Addendum #4 – Total Pages: **31 pages** (including attachments)

- AD04.03** Sheets C101, C201, C202, and C301:
- Remove Sheets C101, C201, C202, C301 and replace them with new and revised civil drawings per **ATT4-02, Revised Grading Plans**.

ATT4-02 - REVISED GRADING PLANS

15 THICK CONC. EDGE NO SCALE

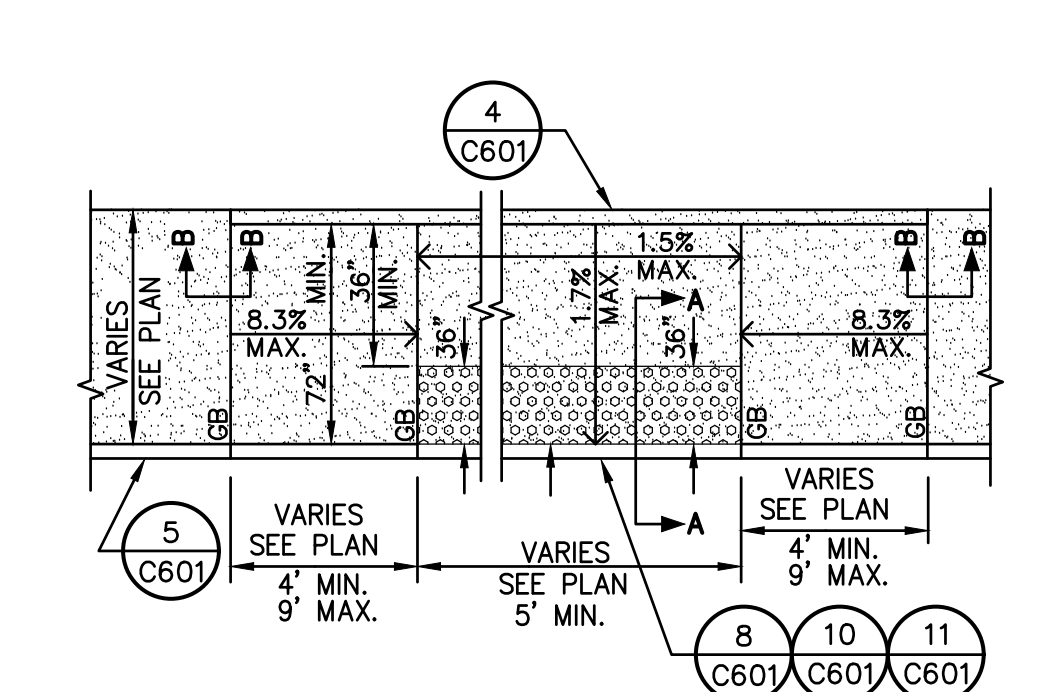
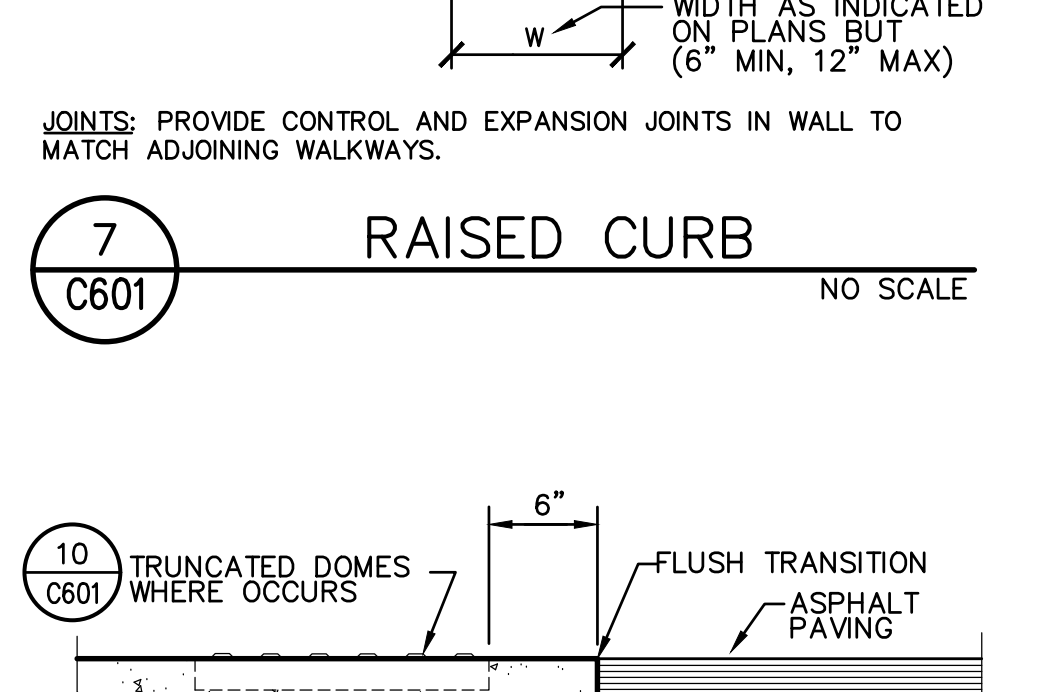
AD04.08 **Q:** The plans call for new asphalt ADA parking stalls. I suggest doing concrete to guarantee ADA compliance and remove and replace another 5' of asphalt around parking stalls to blend into existing asphalt.

Provide thickened edges in accordance with detail 15/C601 provided as part attachment **ATT4-02, Revised Grading Plans**

16 CONCRETE SEATWALL/WALL

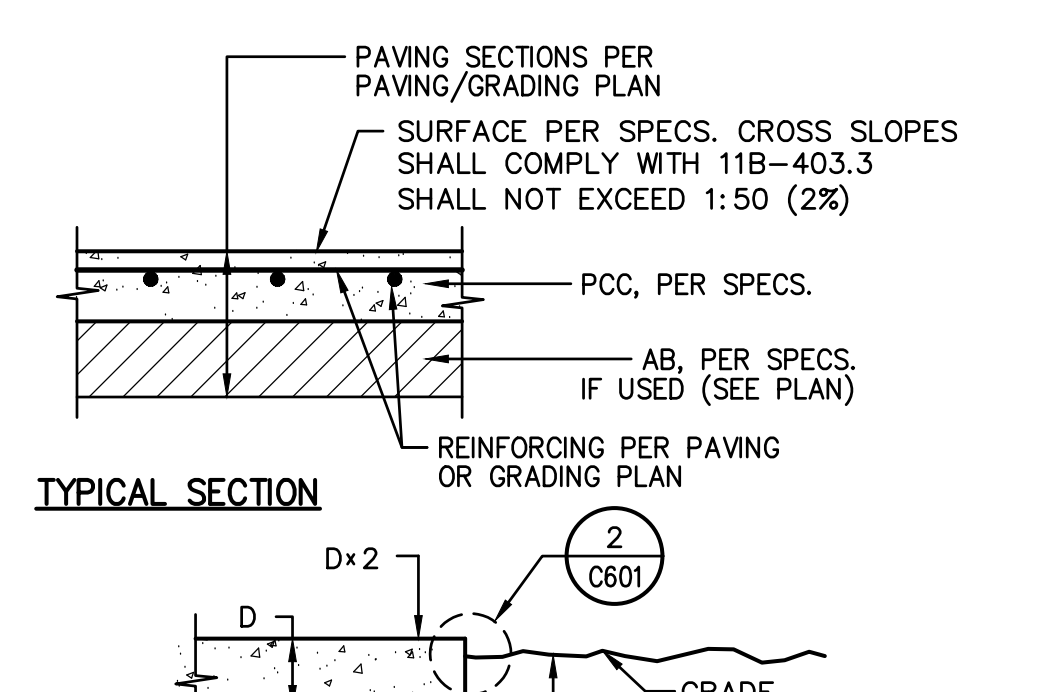
AD04.19 Q: The detail for the seat wall shows it as a 12" wide seat wall but the plans reflect an 18". Please confirm the width of the seat wall.

AD04.20 Q: Plan calls for new "Site Wall". Please provide details and dimensions of site wall

A: Seat walls are 18" wide, see new detail per attachment **ATT4-02, Revised Grading Plans**.

A: See Detail 16/C601 per attachment **ATT4-02, Revised Grading Plans**.
